Revised Traffic Impact Statement

SLR Ref No.: 620.V31023-L01-v1.0 Response to FIL Traffic Matters 20250807.docx

Mixed-use Tower Development – 332-334 Water Street, Fortitude Valley
EDQ Further Issues Letter – Response to Traffic Matters

Figure 3 Proposed Traffic Arrangements

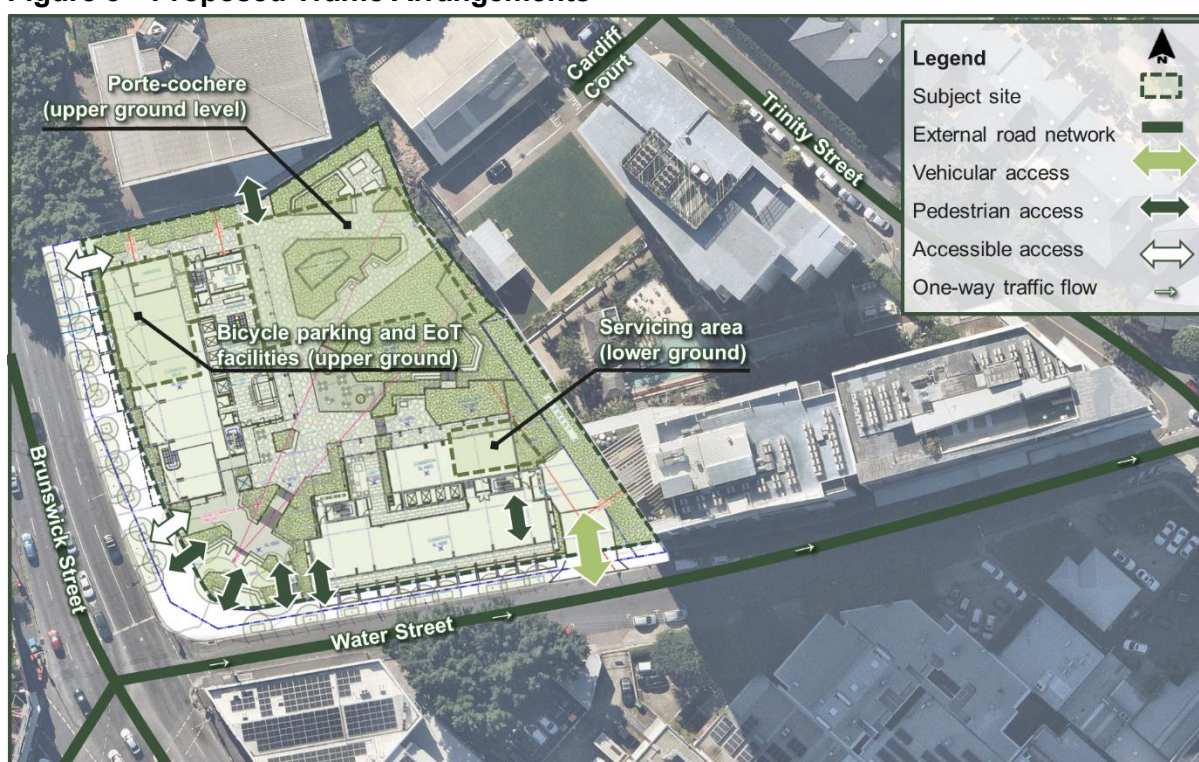
“Identify accessible entries and pathways on parking layout plans.”

- The Amended TIS (refer to *Figure 3*) to identify the site’s proposed accessible entrances to the external footpath network.
- As detailed in *Section 5.2* of the Amended TIS, a single car parking space for Persons with a disability (**PWD**) is required to satisfy the relevant National Construction Code (**NCC**) requirements and is provided on the upper ground level. Whilst there do not appear to be any barriers to accessibility for wheelchair users between the PWD parking space and the building lobby, it would be reasonable to impose relevant condition/s with any specific accessibility requirement.

FIGURE SK03

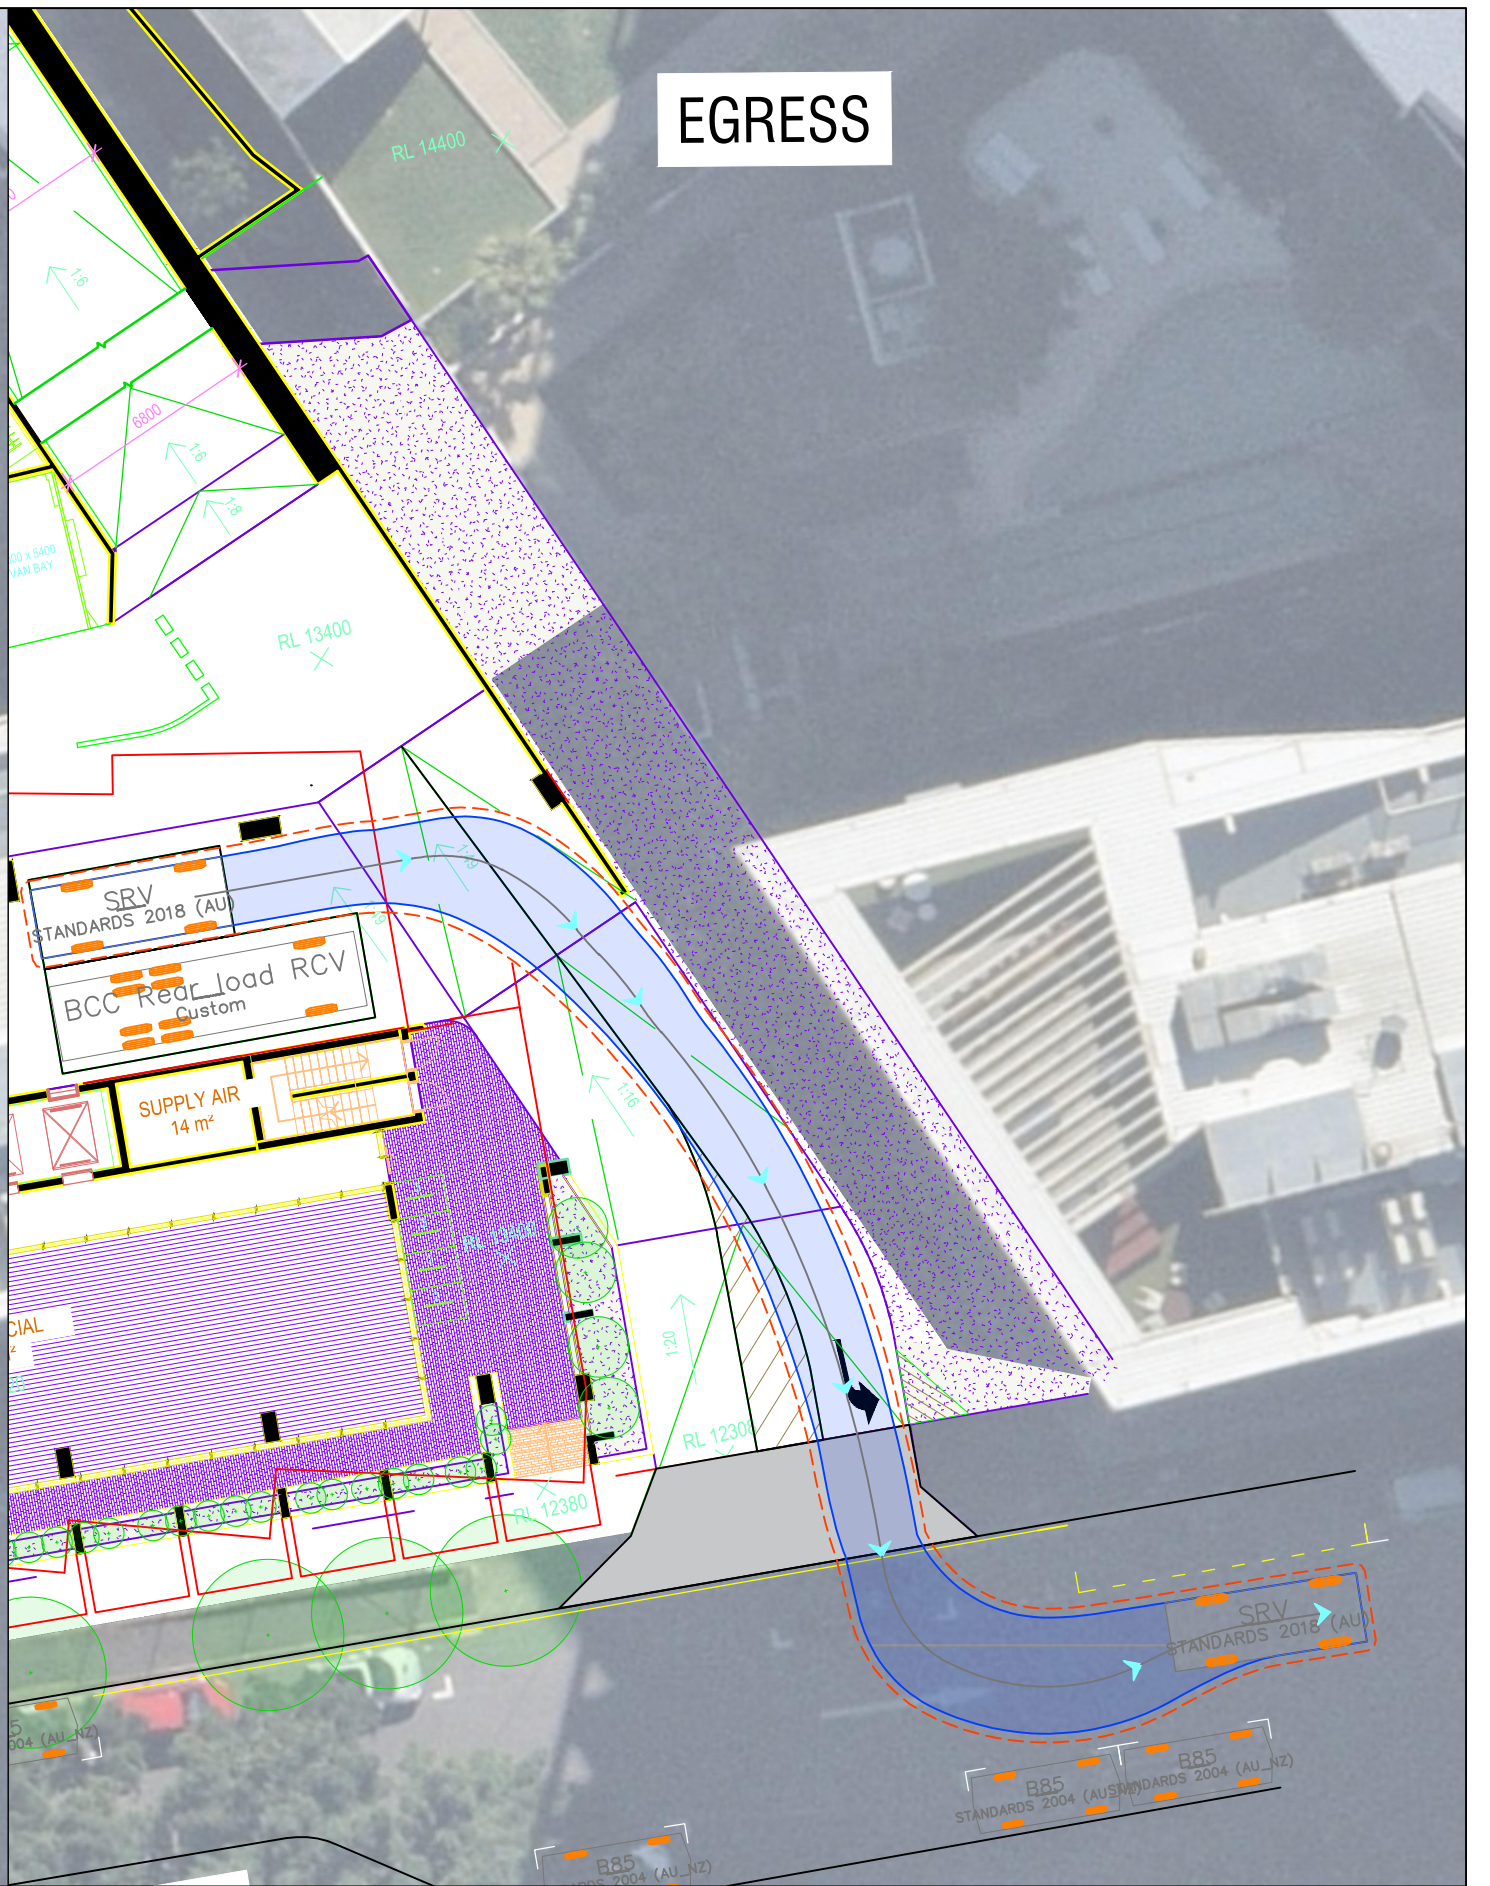
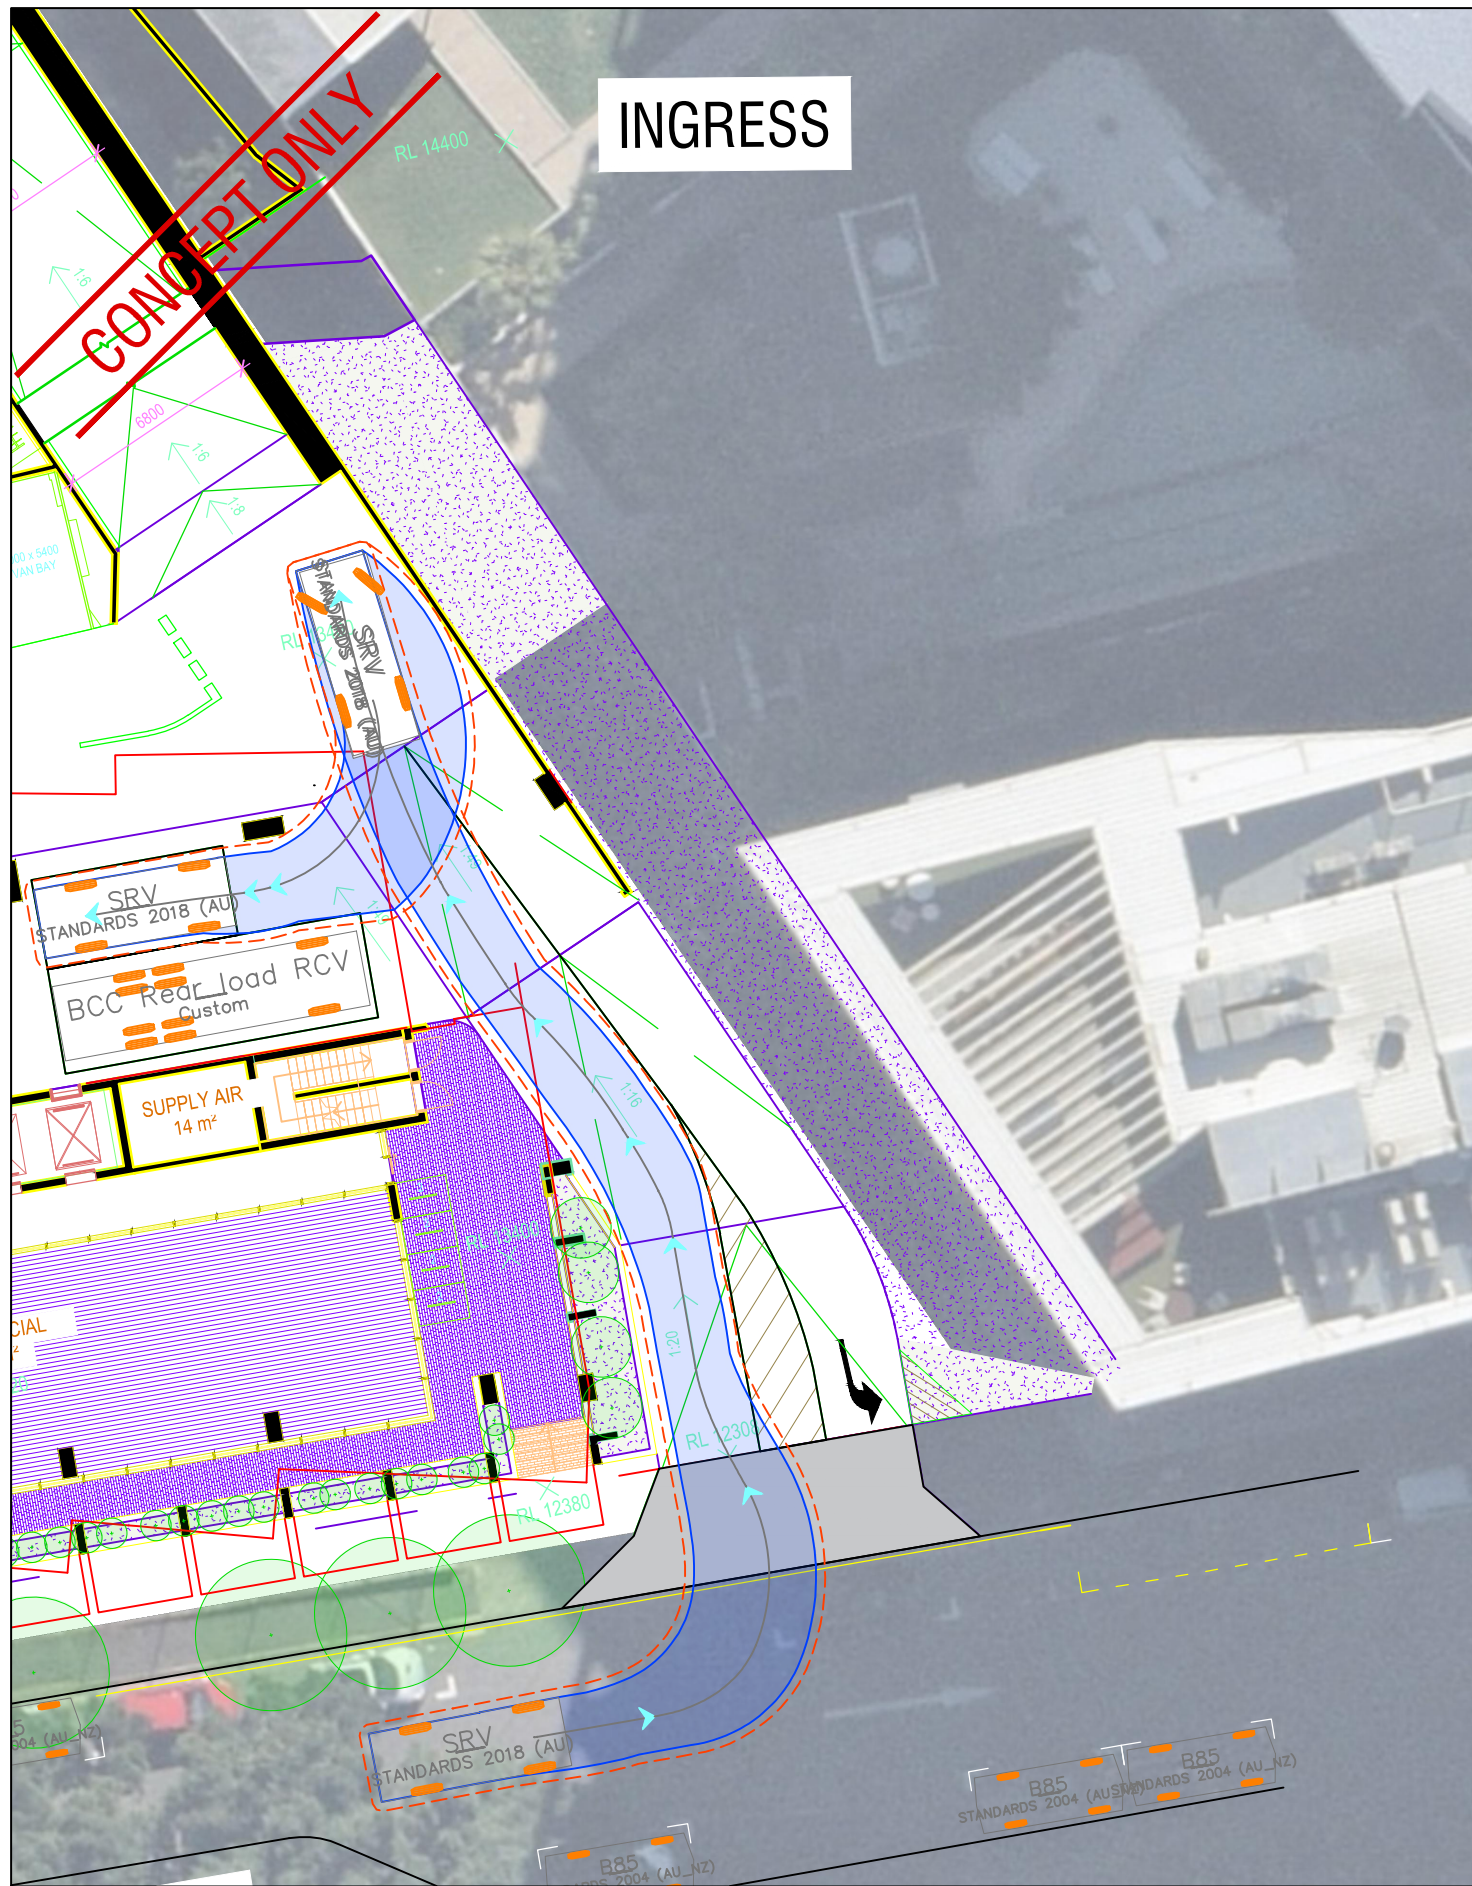
- c) The text used in swept path is contaminated showing only dots. Please updated the swept path layouts with proper texts.
- d) For the entry ramp from Water Street, please add a divider (as per AS2890.1, Section 2.5.2 (b)) between entry and exit path from the property boundary to control gate as the entry we classify as circular entry.

- The referenced issue may have occurred when pdf’s of the TIS were uploaded to EDQ’s assessment portal. Notwithstanding, updated swept path assessments have been prepared and are included at *Appendix C* of the Amended TIS. SLR would be happy to provide pdf’s and/or electronic versions of the swept path assessments directly to EDQ if this issue persists.
